MODIFICATION #3
MODIFIED SECTION FROM PROJECT BOUNDARY TO WESTERLY ROUNDABOUT (W/ TRANSTION)

Request for a
Modification to a Road Standard
and/or Project Conditions

Project Number: TM 5571/5572

LILAC HILLS RANCH 2.2C LIGHT COLLECTOR MODIFICATION TO ROAD STANDARDS

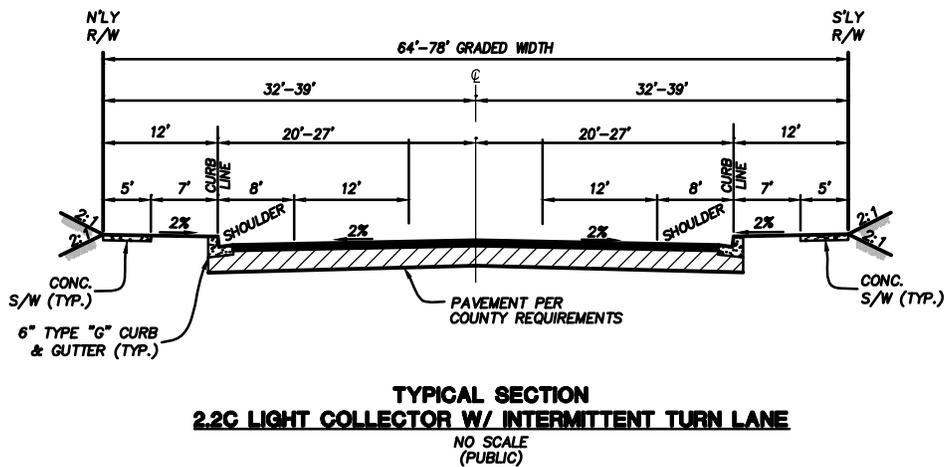
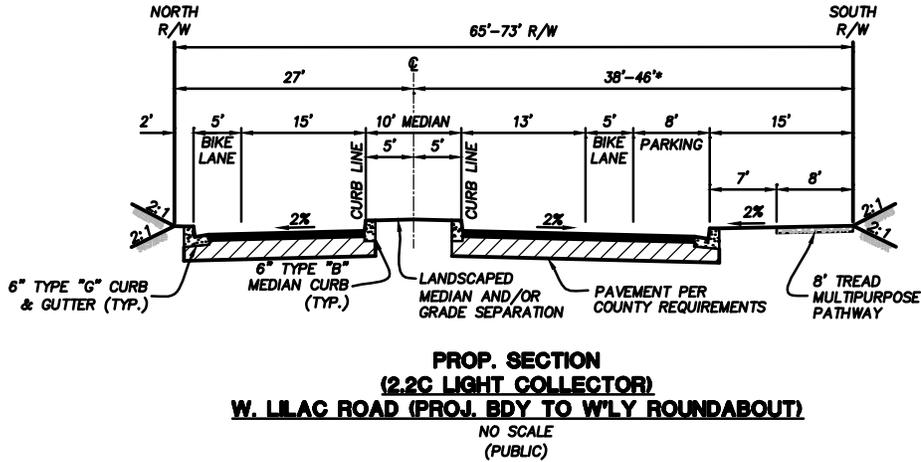
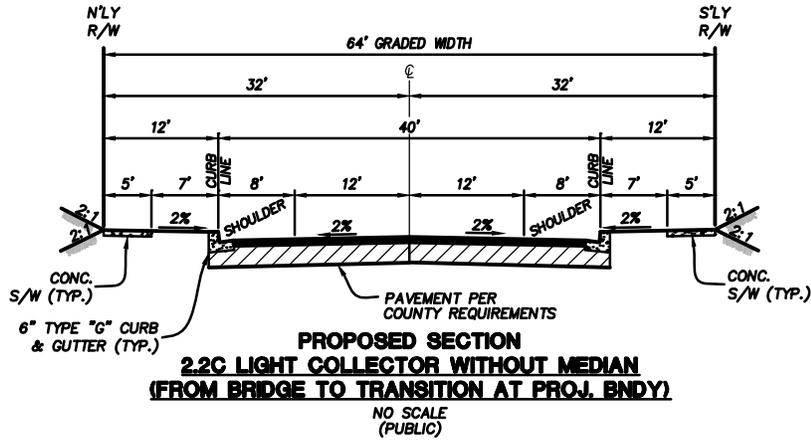
Requested Modification (attach engineering sketches showing existing layout, details, and notes): The standard road section for Light Collector Road 2.2C with intermittent turn lane has a 54' wide curb to curb width on 78' ROW, 8ft shoulders, and 12' pkwys. The requested modification to the road standard is to decrease the pkwy to a 2' pkwy along the north, add a proposed 10' median with 18' (with 5' bike lane) of pavement plus 8' parking and 15' pkwy along the south. West of this modification, the road section consists of the standard for 2.2C Light Collector without an intermittent turn lane, having 40' wide curb to curb width on 64' ROW, 8' shoulders, and 12' parkways. The modification request includes a transition from this typical section to the proposed, non-standard 2.2C Light Collector east of the subdivision boundary. The 320' transition safely handles the reduction of the northern pkwy from 12' to 2' and the introduction of a median. See Attachments 1, 2, & 3.

Reason for Modification (provide attachment if additional space is required): Additional off-site grading and habitat disturbance as well as the need for additional condemnation to obtain off-site ROW would be required. The 320' taper is necessary to provide drivers a safe transition between the standard 2.2C Light Collector and the proposed, onsite, modified 2.2C Light Collector. The proposed median acts as a splitter and is important for proper channelization through the roundabout. West Lilac would operate at LOS D or better with or without the requested modification. The modification would provide additional parking onsite in front of rear entered lots, enhanced landscaping (w/ the median) through the project.
